Project: City of Coos Bay – Egyptian Theatre Restrooms

Date: July 10, 2013

Issued By: Sy Allen, PE – ZCS Engineering, Inc.

## PROJECT ADDENDUM #2

**ADD1-1**

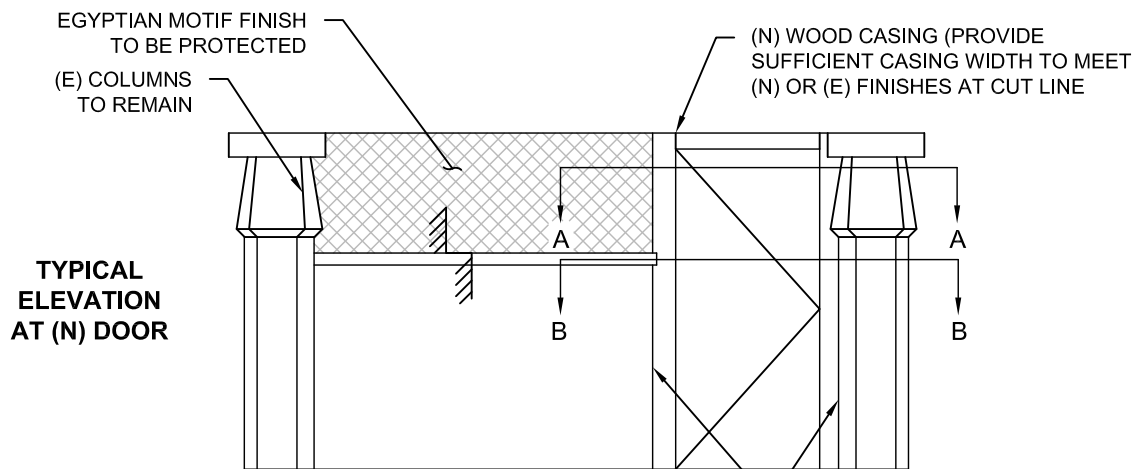
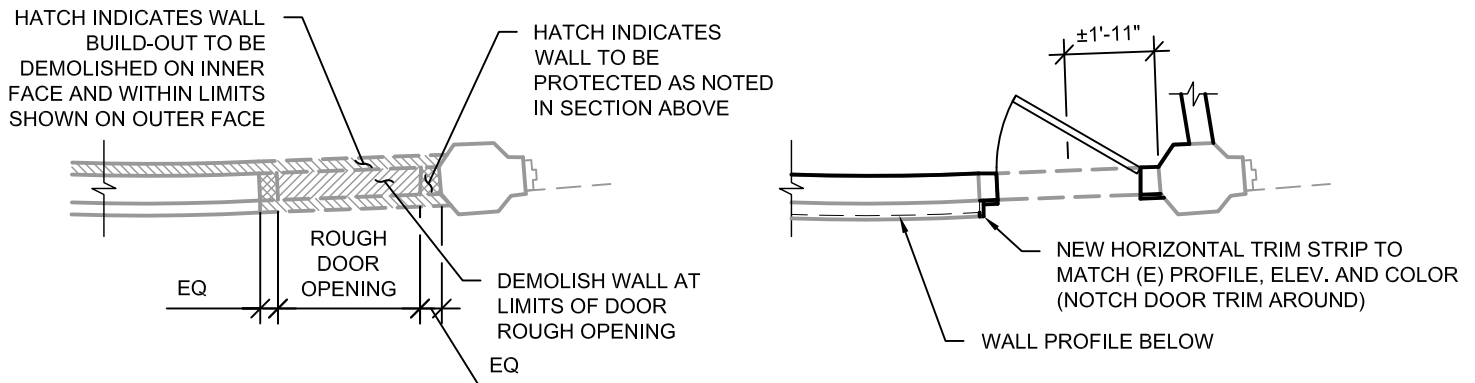
1. Sheet Add1-1 shall be added to the contract drawings as part of the plan set. This sheet contains clarifications on the construction and detailing of the changes to the existing wall at the new restroom. All features of construction shown on this sheet apply or are similar for the alternate restroom.
2. Mechanical sheets M-2, M-3, and M-3.1 have been updated to reflect changes to exhaust routing and ceiling construction.
3. Electrical sheet E-4 has been updated to reflect changes to lighting fixture re-installation.

1. PROVIDE NEW FINISHES TO MATCH (E) AT RETURN OF HORIZONTAL TRIM BAND AND WALL RETURN BELOW (SEE SECTION 'B-B') ASSUMED FINISH IS PAINTED PLASTER - FIELD VERIFY.
2. ALL FEATURES OF CONSTRUCTION NOT SHOWN TO BE PER ORIGINAL CONTRACT DOCUMENTS. IF CONFLICTS OCCUR, NEW DOCUMENTS SHALL SUPERCEDE OLDER DOCUMENTS. CONTACT ZCS ENGINEERING IN THE CASE OF FIELD CONFLICTS.
3. SUBMIT MOCK-UP OF FINISH TEXTURE W/ PAINT FOR APPROVAL PRIOR TO PATCHING/FINISH OPERATIONS.
4. G.C. TO PROVIDE FIELD INSTALLED WOOD CASING OVER METAL DOOR FRAME IN FIELD - PROVIDE NON-SHRINK CAULK FROM CASING TO FRAME. PAINT FRAME AND CAULK IN FIELD TO MATCH ADJACENT FINISHES - COLOR BREAK FROM INSIDE TO OUT TO OCCUR AT DOOR.
